Building Permit B17000858

11447 Rowley Road Clarksville, MD 21029

We are submitting a waiver request and additional information to our request for an amendment to the Building Permit B17000858 for the above referenced project, which is currently in construction. We propose to replace an existing residential deck, a revision from what was shown in the approved permit.

Re: 11447 Rowley Rd. - Deck Replacement

Typical Deck Post to Footing Detail @ Septic Tank

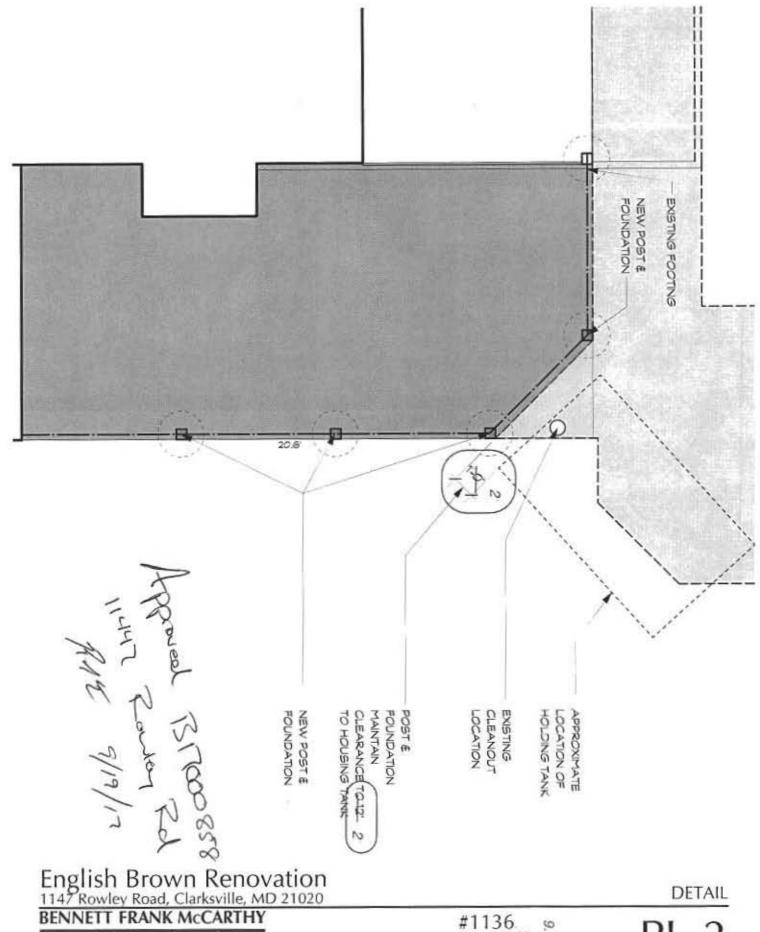
I understand that a waiver is required for our deck to be reconstructed over the existing holding tank. The bottom of the deck structure shall be 5' or greater above the tank cleanout. Mr. Robert Freemon of your office reviewed this on site with our contractor, Laurent Lefleur on 13 September 2017.

Additionally we are requesting a waiver that if foundations are required closer than 5' horizontally to the tank, that these footings be permitted based upon the structural conditions noted in the attached sketch. This sketch shows the requirements our engineer has recommended for placements as described.

Please see attached homeowner waiver request and structural detail for deck footings placed as close as 2' to the tank.

911139 Amended Zoning Plot Plan

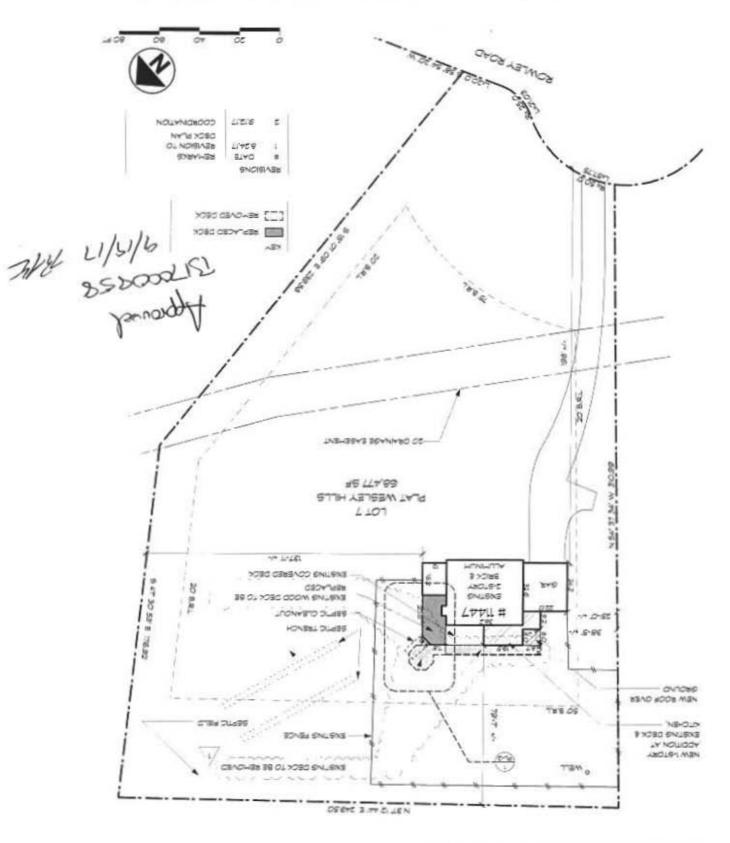
I have attached the drawings we forwarded to Mr. Freemon via Mr. Oswald last week. I have annotated them to note footings held 2' to the tank.

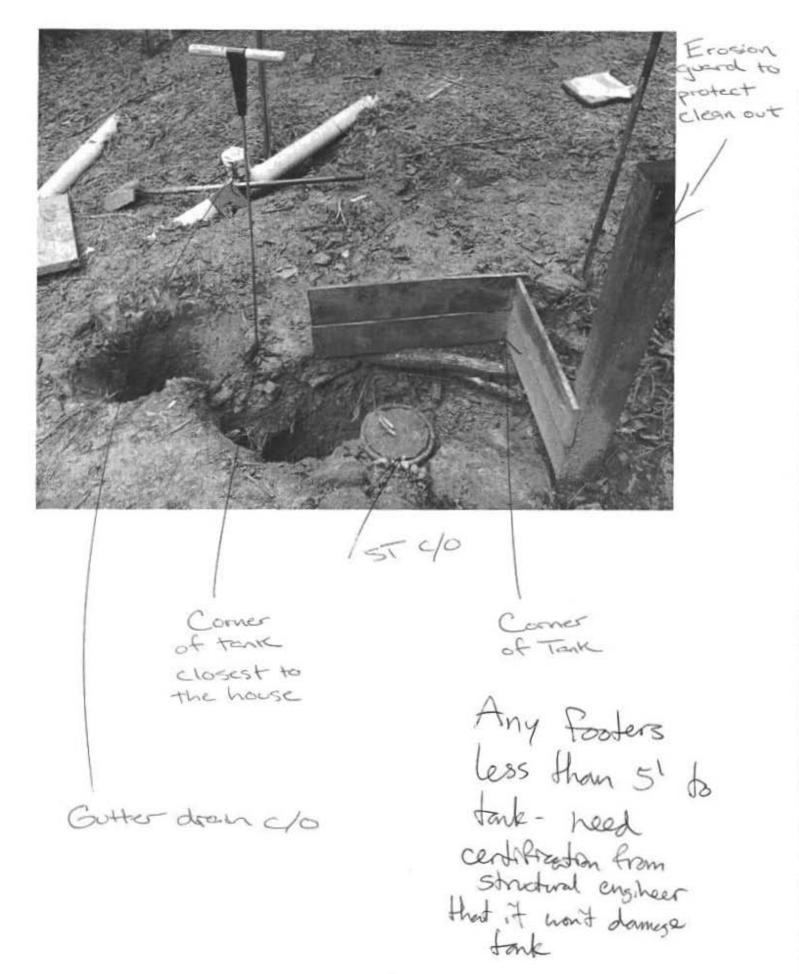
- Will be at least 5' above the tank. (From bottom of deck to tank lid)
- If he is going over the tank it will only be over it to the edge of the clean ast.

(Nearest to house)
- It footer is I' away above grade of the tank it will neet a depth equal to the bottom of the lid.
